**ADDENDUM NO. 2**

**WATER POLLUTION CONTROL FACILITY  
COMPREHENSIVE UPGRADE**

**TOWN OF KILLINGLY, CT**

**JULY 10, 2018**

TOWN OF KILLINGLY, CONNECTICUT WATER POLLUTION CONTROL FACILITY UPGRADE		APP'D	RDW
PROJ NO: 13543	DATE: 6/29/2018	DRAWN BY	HED
<b>WRIGHT-PIERCE</b> Engineering a Better Environment		REVISIONS	FIGURE: <b>A1</b>
		NO. 1 NO. 2 NO. 3	ADDED EXISTING LADDER   
ADDENDUM NO. 2 REFERENCE DWG: A-4

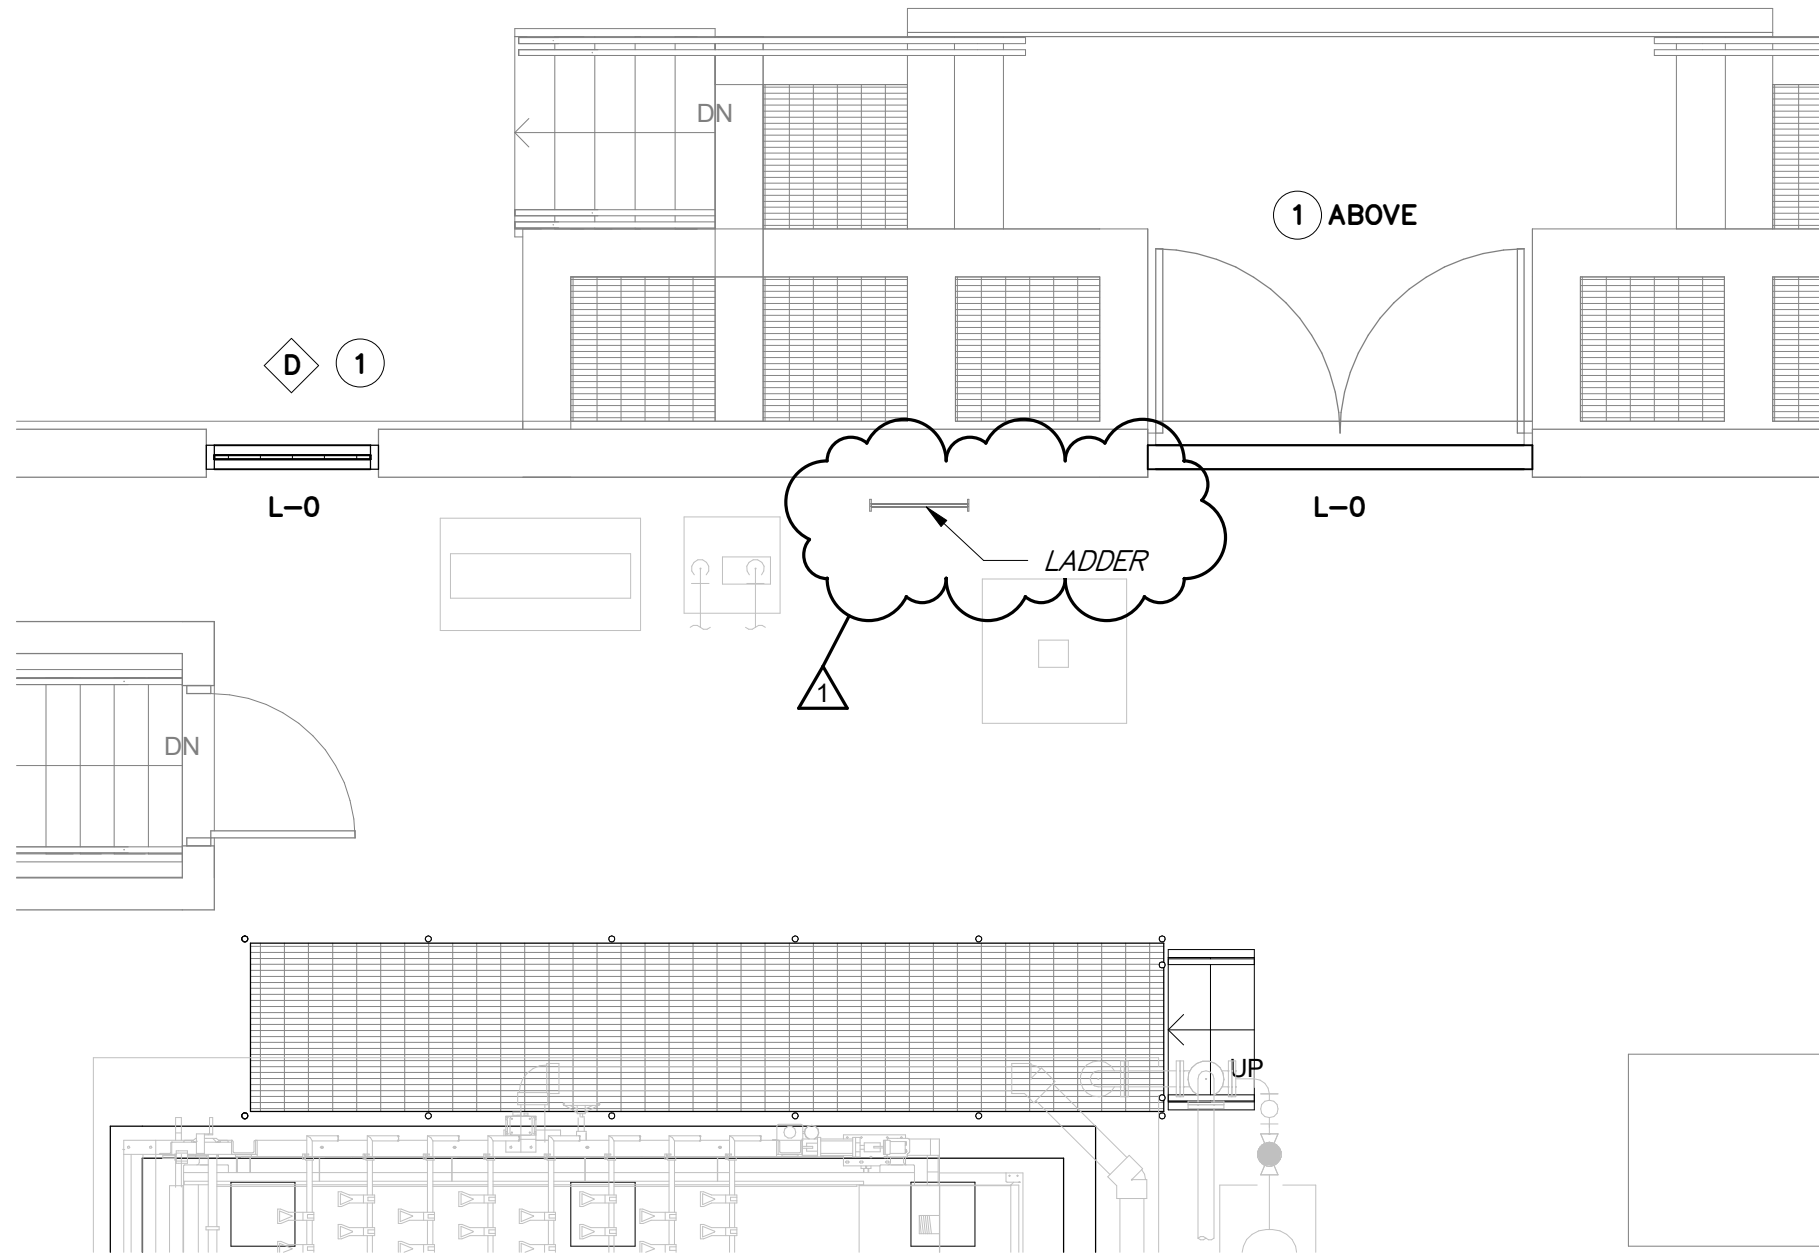
1. Drawing C-12 Drawing C-12, detail “Chainlink Fence and Locking Double Gate with Barbed Wire”, **DELETE** “Danger No Trespassing” signs.
2. A: The “Danger No trespassing” signs shown on the ‘Chainlink Fence and Locking Double Gate with Barbed Wire’ detail on drawing C-12 are not required and have been deleted per this addendum
3. Drawing A-4, First Floor Modification Plan, **ADD** existing ladder to floor plan as shown in Figure A1 as attached to this addendum.
4. Drawing A-4, Roof Plan, **ADD** existing roof scuttle to roof plan as shown in Figure A2 as attached to this addendum.

TOWN OF KILLINGLY, CONNECTICUT WATER POLLUTION CONTROL FACILITY UPGRADE		NO. 1 2 3	REVISIONS ADDED EXISTING LADDER	DRAWN BY HED	APP'D RDW
PROJ NO: 13543 DATE: 6/29/2018		ADDENDUM NO. 2 REFERENCE DWG: A-11		FIGURE: A3

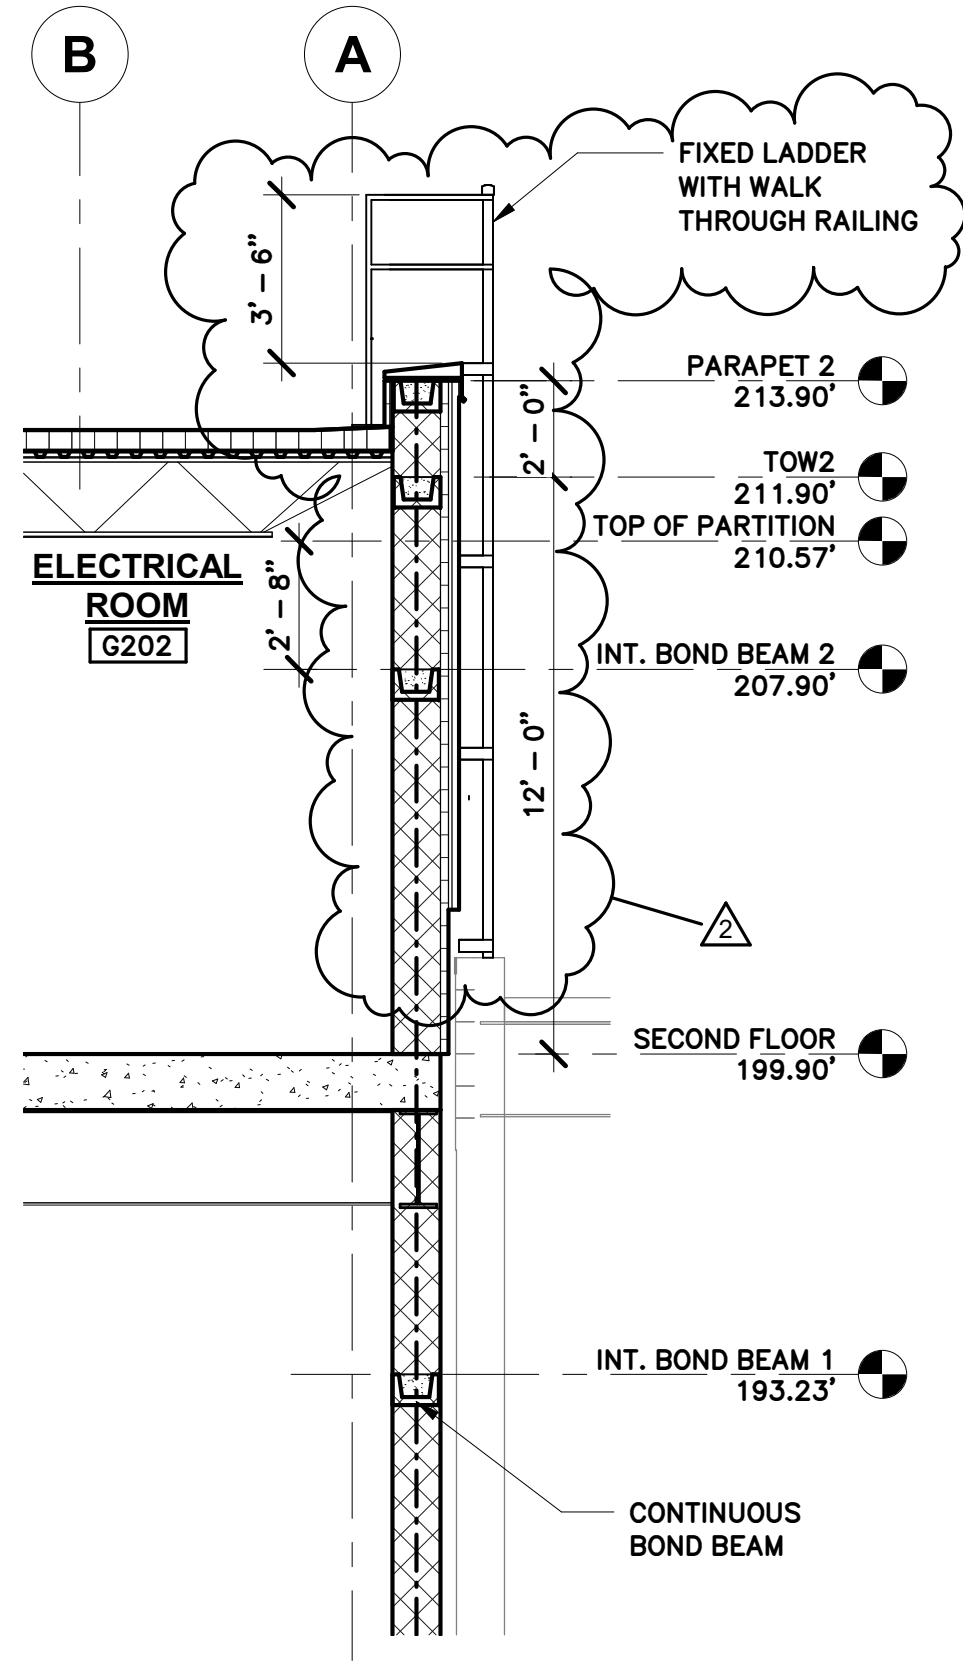
5. Drawing A-11, First Floor Modification Plan, **ADD** existing ladder to floor plan as show in Figure A3.
6. Drawing A-17, Section 2, **ADD** fixed ladder as shown in section in Figure A4.
7. Drawing A-18, Roof Plan, **ADD** existing roof scuttle and fixed ladder as shown in plan in Figure A5.
8. Drawing A-16, Section 3, **ADD** detail tags as shown in Figure A6.
9. Drawing A-18, Wall Section 1, **ADD** note as shown in Figure A7.
10. Drawing E-53, Schematic V, **ADD** solenoid valve addition to the schematic for Conveyor SLCC-3 and SLCC-4 as shown in figure E1.
11. Drawing E-57, Control and Instrumentation Wiring Diagrams III, **ADD** wiring for solenoid valves to MCC-DW as shown in Figure E2.
12. Drawing E-38, Sludge Building Second Floor Electrical Power Plan, **ADD** solenoid valves to floor plan and Equipment Legend as shown in Figure E3.

TOWN OF KILLINGLY, CONNECTICUT WATER POLLUTION CONTROL FACILITY UPGRADE		APP'D	RDW
PROJ NO: 13543	DATE: 6/29/2018	DRAWN BY	HED
<b>WRIGHT-PIERCE</b> Engineering a Better Environment		REVISIONS	
		NO.	ADDED CALLOUTS
		1	
2			
3			
ADDENDUM NO. 2 REFERENCE DWG: A-16		FIGURE: <b>A6</b>

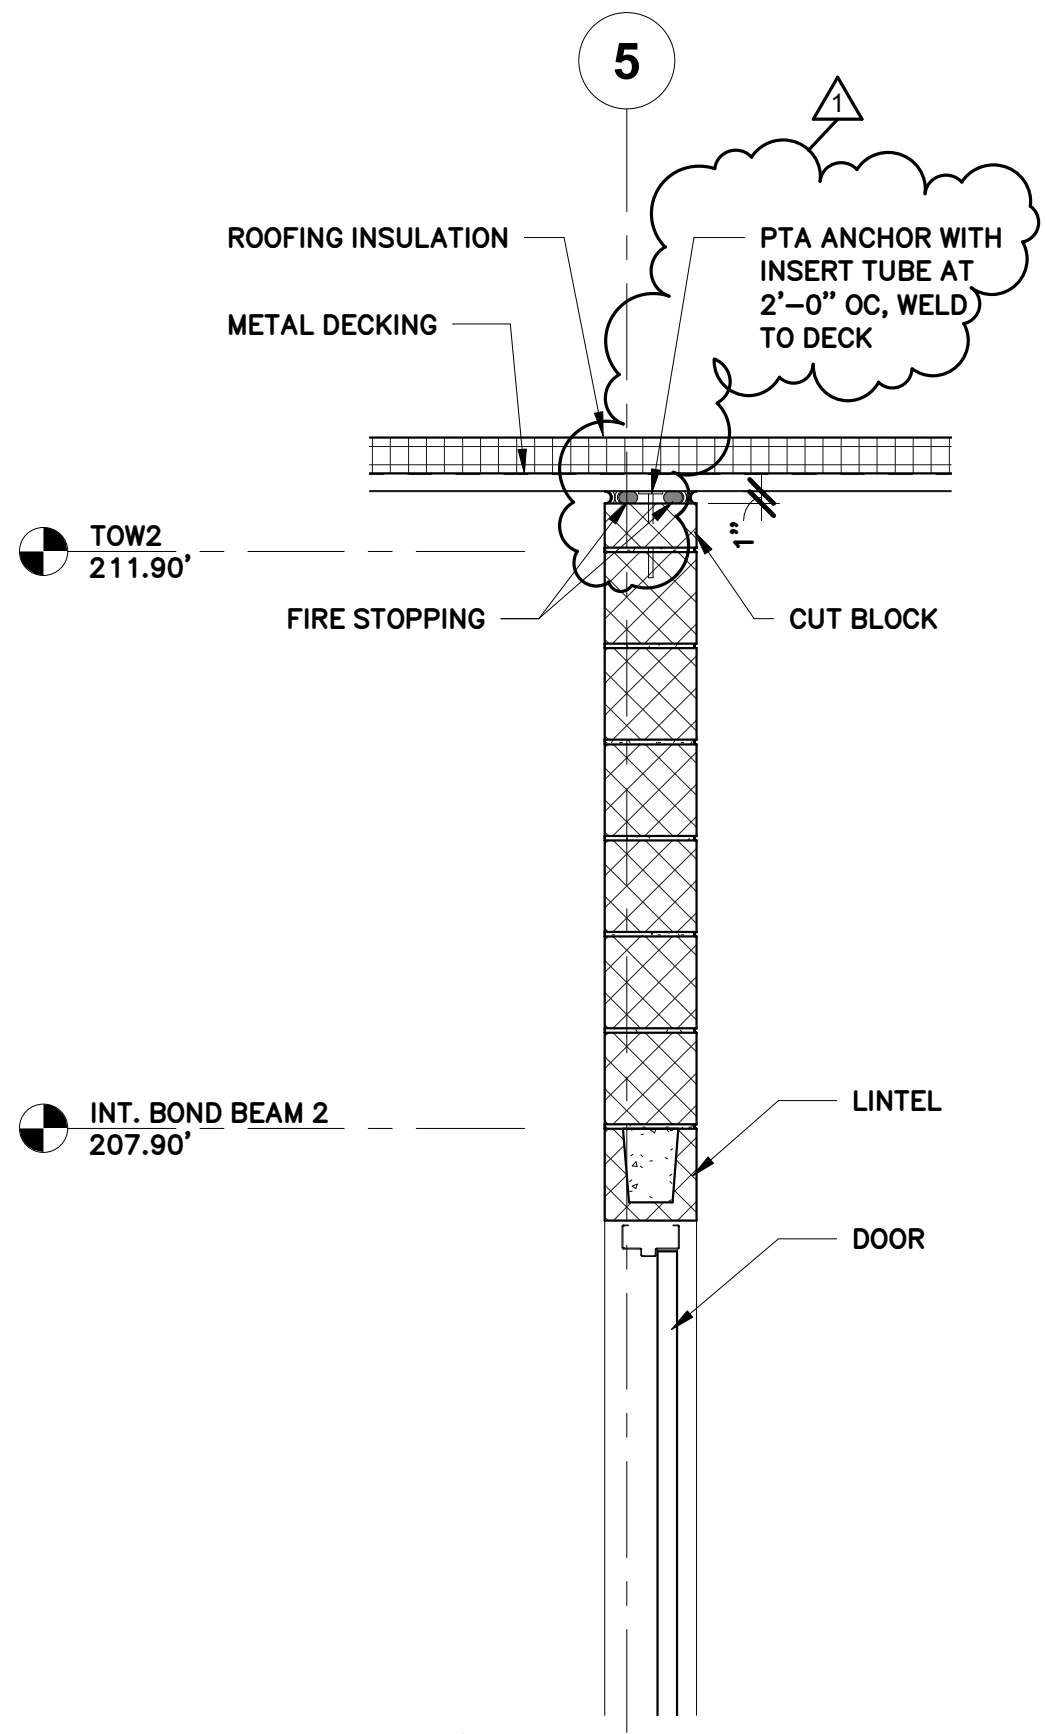
11. *Q: Please provide stair detail for the stair shown in section 3 on A-16*

A: The stair details are on A-24. Figure A6 included with this addendum adds tags to the appropriate details for this stair.
